# Rosefield Solar Farm

Appendix 5.2: EIA Scoping Opinion

## Proposed Rosefield Solar Farm

Case Reference: EN010158

### **Electrical clearance** from overhead lines

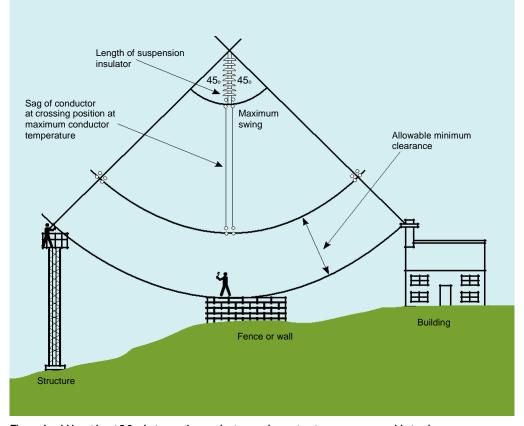
The clearance distances referred to in this section are specific to 400kV overhead lines. National Grid can advise on the distances required around different voltages i.e. 132kV and 275kV.

As we explained earlier, *Electrical Networks*Association TS 43-8 details the legal clearances to our overhead lines. The minimum clearance between the conductors of an overhead line and the ground is 7.3m at maximum sag. The sag is the vertical distance between the wire's highest and lowest point. Certain conditions, such as power flow, wind speed and air temperature can cause conductors to move and allowances should be made for this.

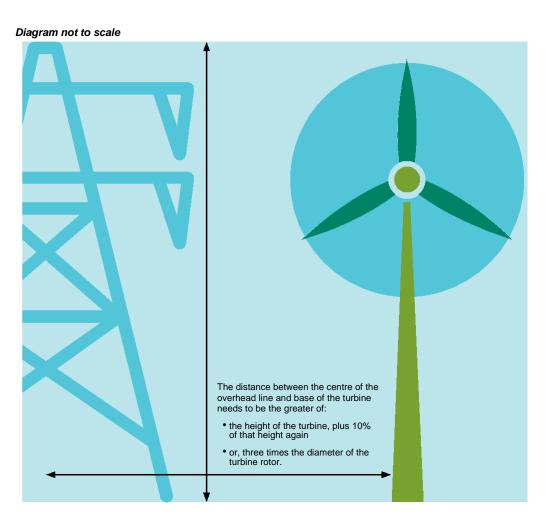
The toppling distance is the minimum horizontal distance between the worst-case pivot point of the wind turbine and the conductors hanging in still air. It is the greater of:

- the tip height of the turbine plus 10%
- or, the tip height of the turbine plus the electrical safety distance that applies to the voltage of the overhead line.

To minimise the downward wake effect on an overhead line, the wind turbine should be three times the rotor distance away from the centre of the overhead line.

Wake effects can prematurely age conductors and fittings, significantly reducing the life of the asset. For that reason, careful consideration should be taken if a wind turbine needs to be sited within the above limits. Agreement from National Grid will be required.
